Planning Commission Meeting Agenda Hartland Township Hall Thursday, July 22, 2021 7:00 PM

Submitted By:	Troy Langer, Planning Director
Subject:	Site Plan/PD Application #21-005 Redwood Living Planned Development (PD) – Preliminary Site Plan
Date:	July 15, 2021

<u>Site Plan Application #21-005 (Redwood Living Planned Development) – Preliminary Planned</u> Development Site Plan

DEVELOPMENT PLANS FOR REDWOOD LIVING **RESIDENTIAL DEVELOPMENT** HARTLAND TOWNSHIP, MICHIGAN

PRELIMINARY SITE PLAN

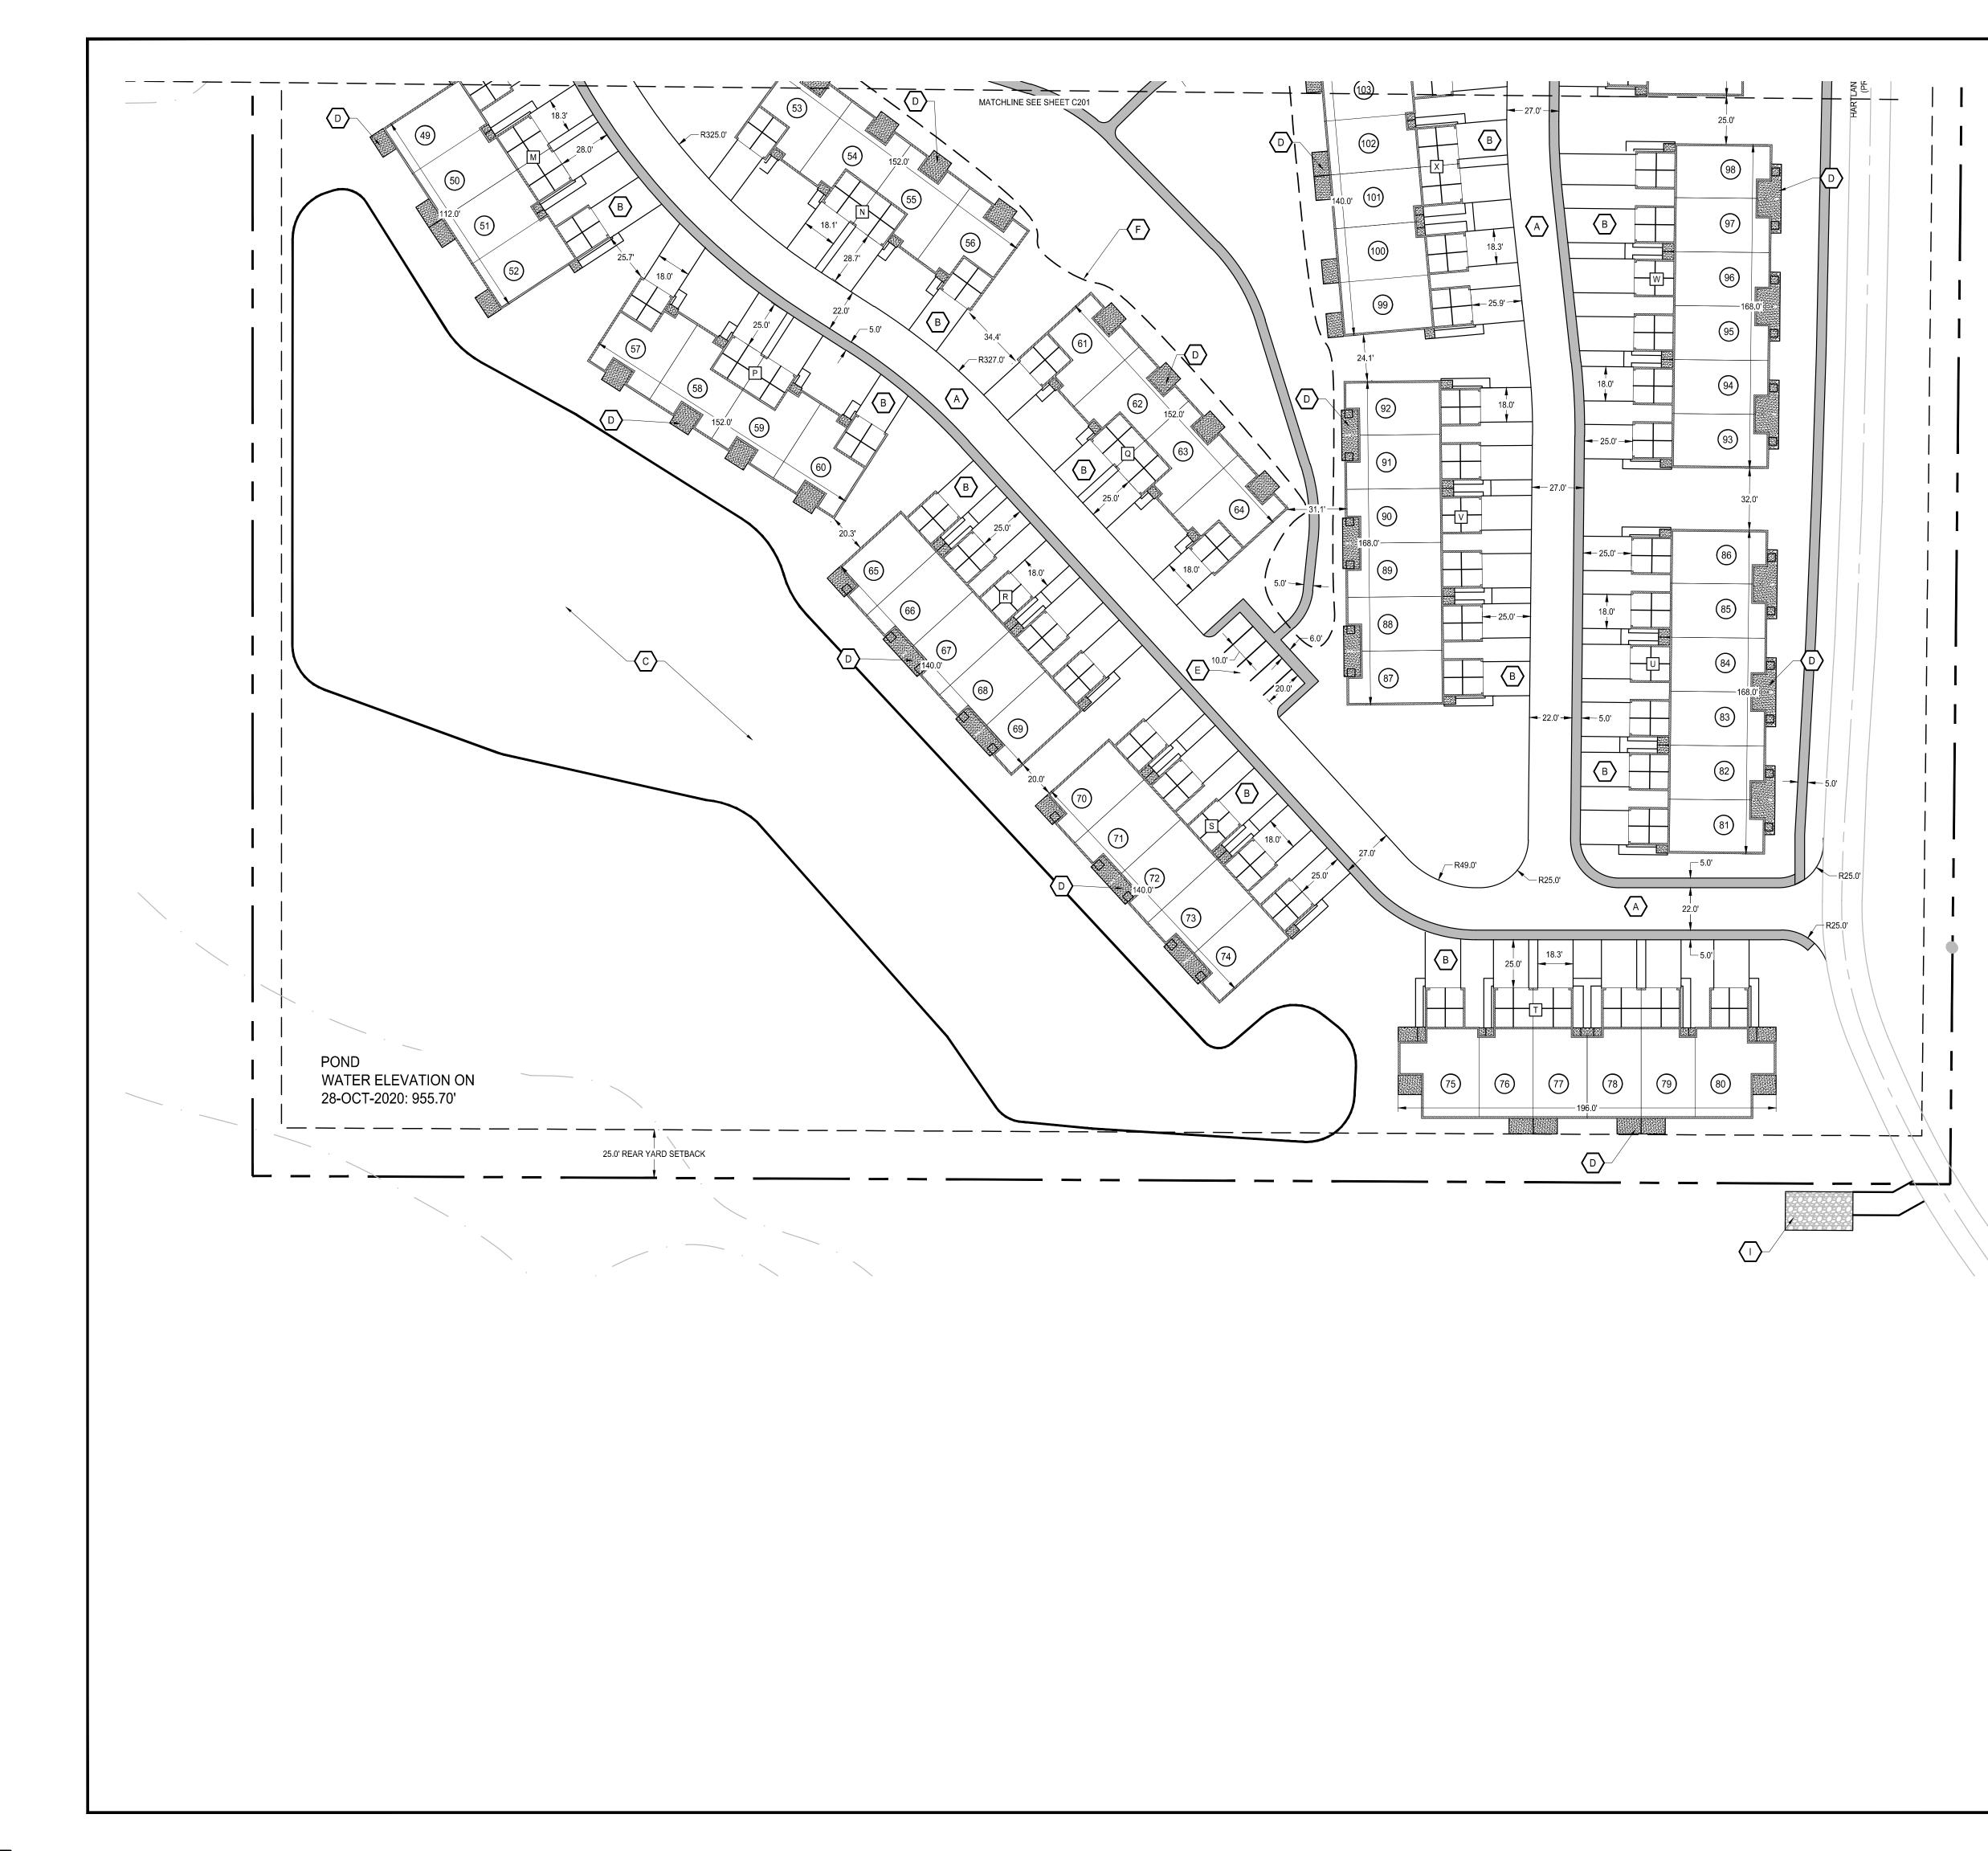
Sheet C200 lists the proposed setbacks for the project area are as follows: front (50 feet); side (15 feet) and rear (25 feet), and setback lines for side and rear are shown on the plans. The front setback line is not shown. Staff is unsure how the applicant arrived at those setback designations or locations for the setback lines. Clarification may be required.

Per Section 3.1.7, the required setbacks are as follows: front yard (30 feet); side yard (10 feet); and rear yard (25 feet). These standards are somewhat difficult to apply in this development as the buildings are not on individual parcels nor are individual building envelopes proposed. Sheet C200 provides proposed dimensional standards for building separation. The following chart lists the proposed standards and closest distance between buildings for each category.

LANDSCAPE PLAN **ENLARGEMENTS**

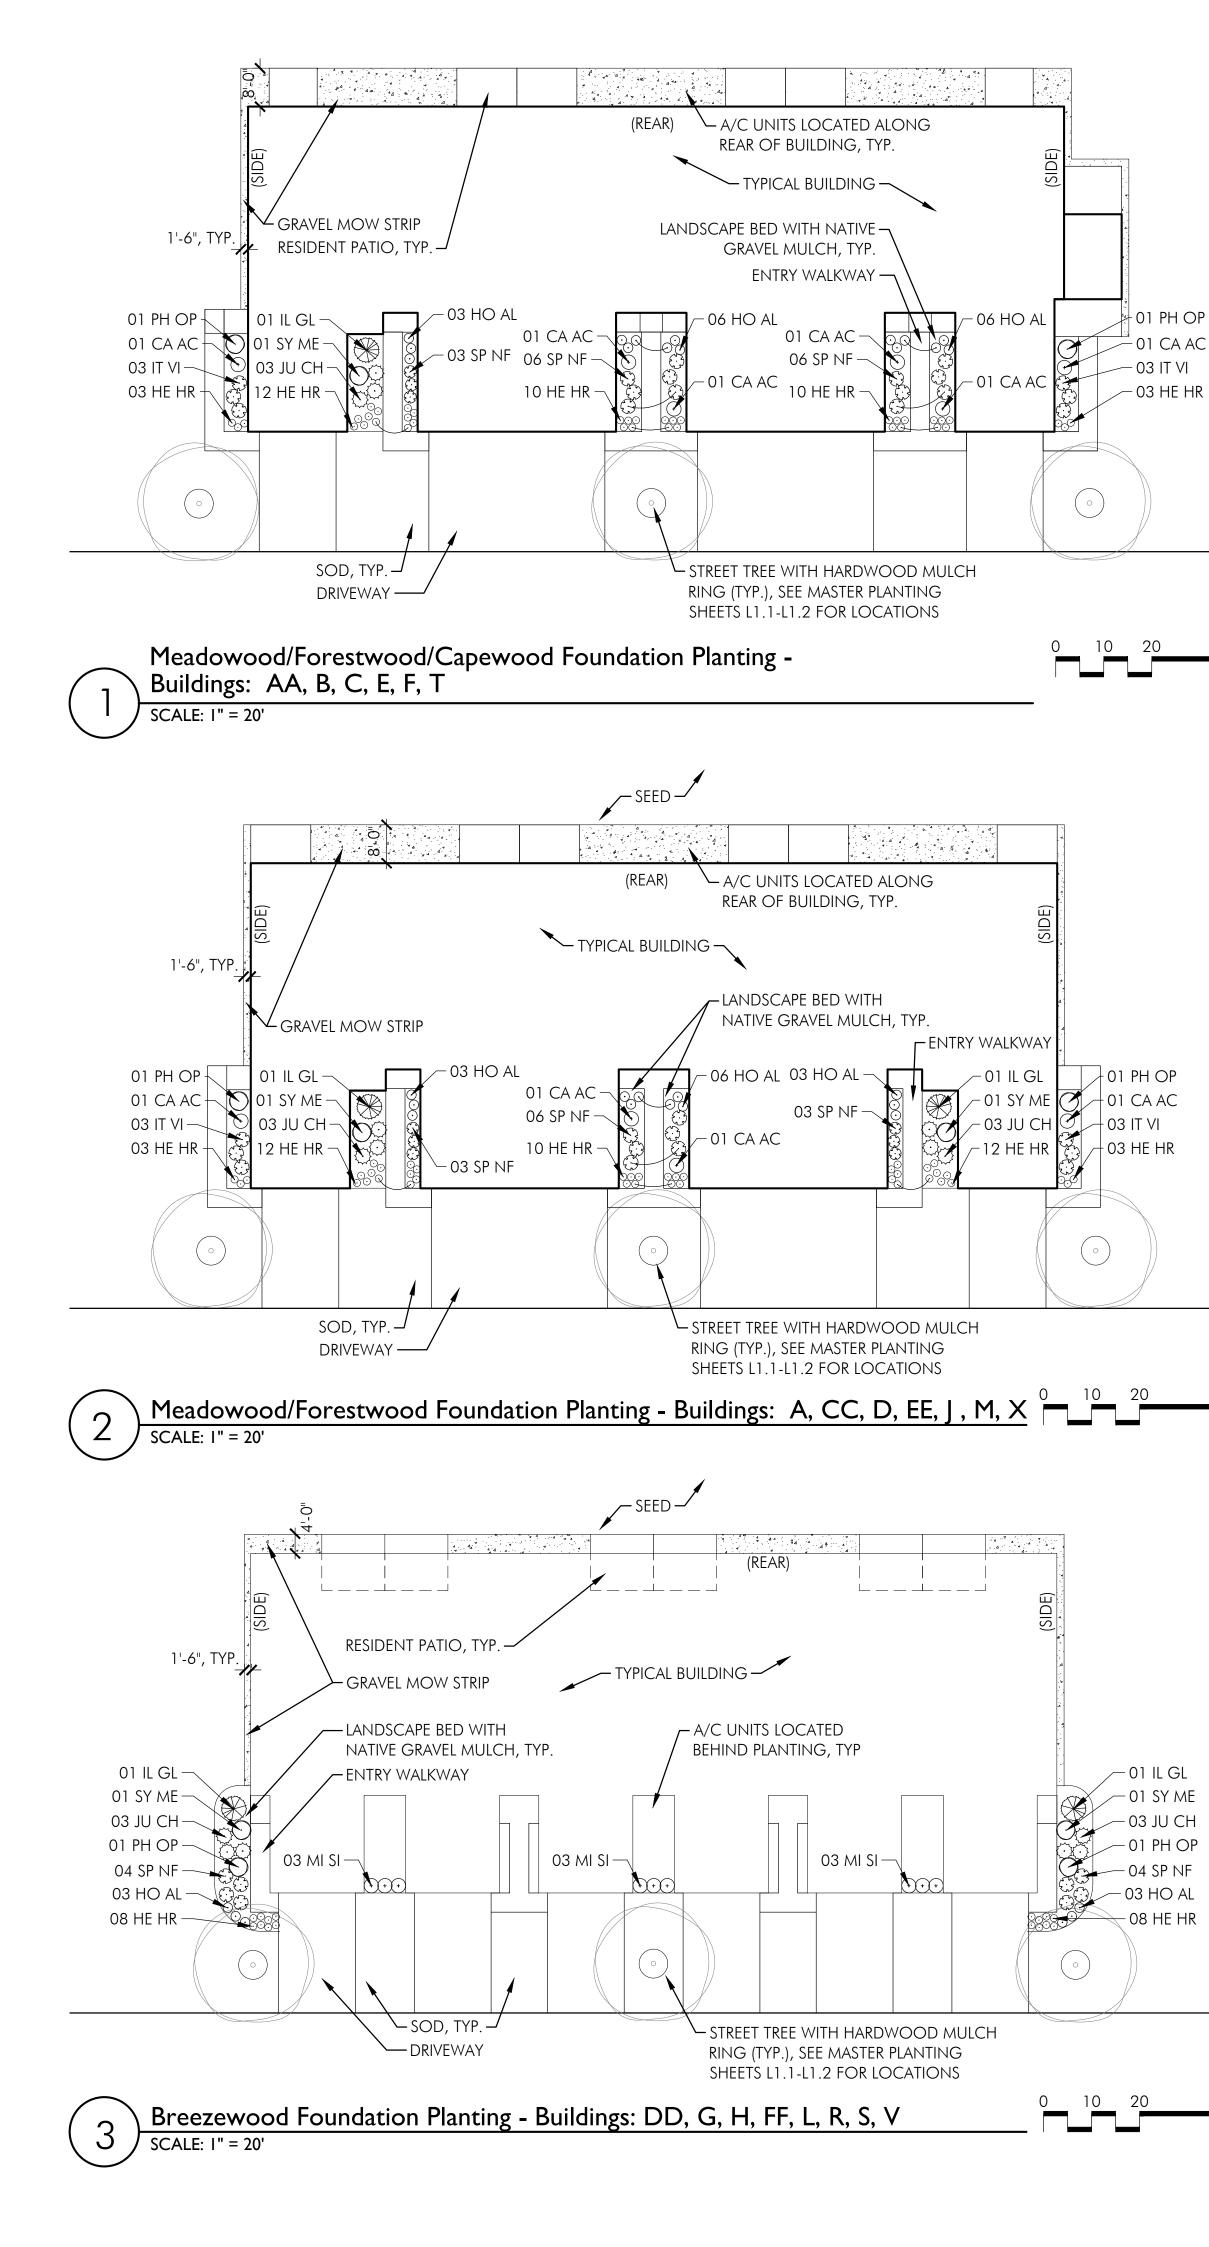
Section 5.11 does not provide landscape standards for apartment buildings. Foundation planting plans for each building model are provided in the plan set on Sheet L1.4 (Typical Foundation Planting). All planted areas will be maintained by Redwood. Irrigation is provided for all front lawns and a minimum of ten (10) feet surrounding the sides and rear of each building. Planting plans for the entrance sign, leasing office, and pavilion are shown on Sheet L1.3.
